TO: Quality Assurance Program Topical Report - Controlled Copy Owners
Dorothy Bruce
FROM: Dorothy Bruce, QAP Coordinator
SUBJECT: Quality Assurance Program (QAP) Topical Report - Millstone Power Station
Revision 22, Change 5 (Document No. MP-02-OST-BAP01)

Summary of Changes to NUQAP Rev. 22 Incorporated as Change 05

1.8 ORGANIZATION CHARTS

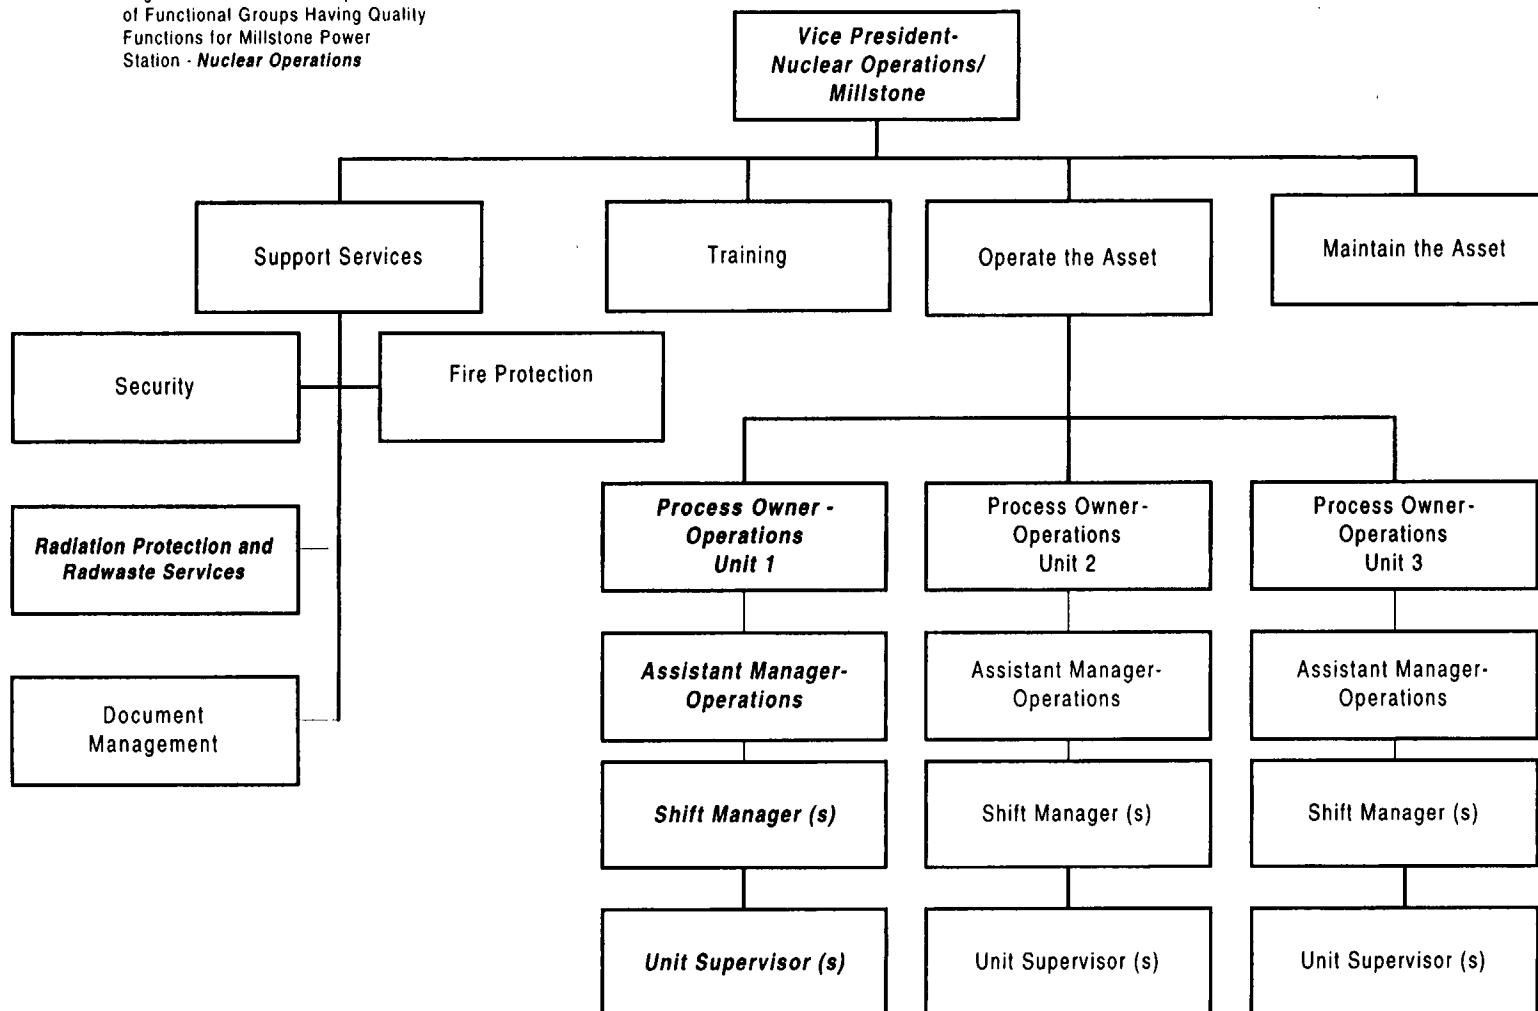
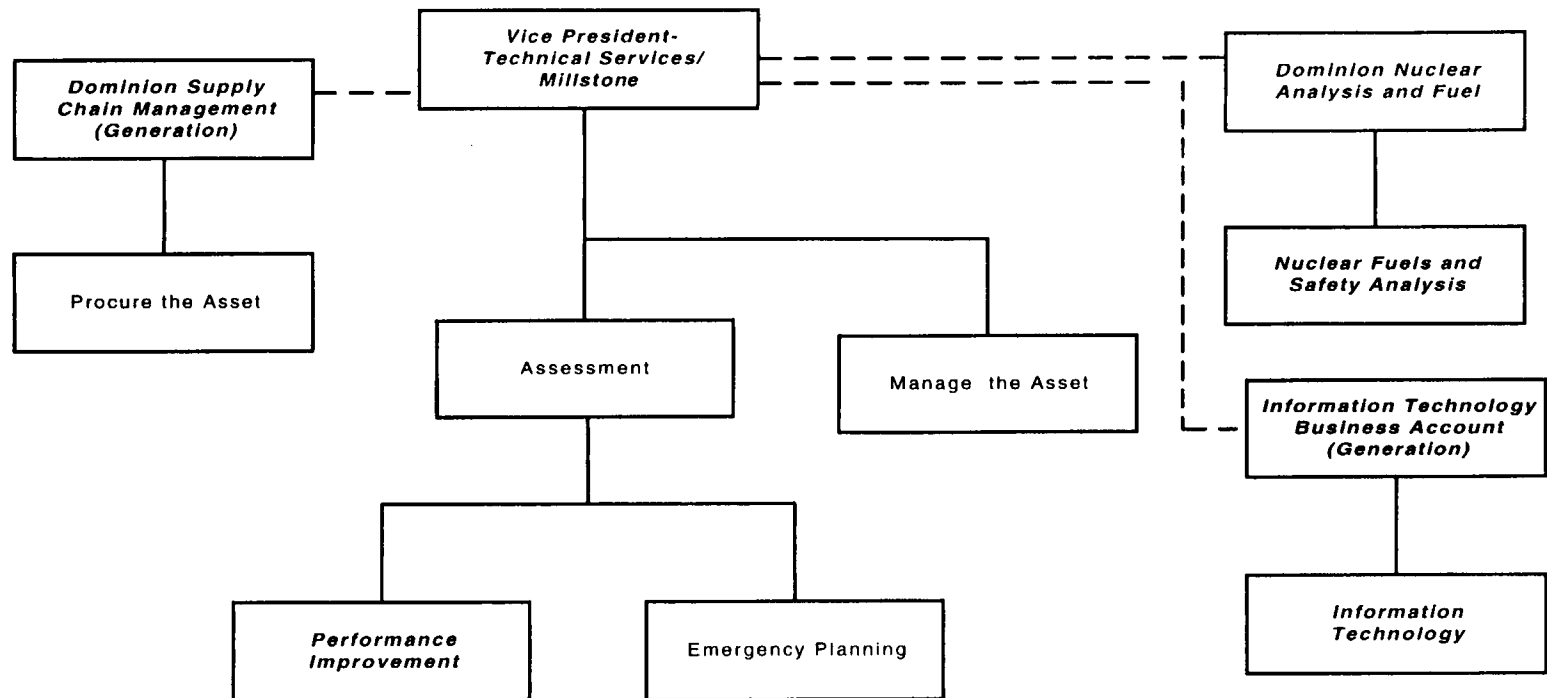
| <u>Section</u> | <u>Summary Description of Changes</u> | <u>Reference</u> |
|-----------------------|--|-------------------------|
| Section 1.0 | "Defines "Dominion Nuclear Connecticut, Inc. As the licensee; "NUQAP" changed to "QAP; Describes organization as structured under Dominion Nuclear Connecticut, Inc. Changes include modifications to the Organizational charts. | Request 01-02 |
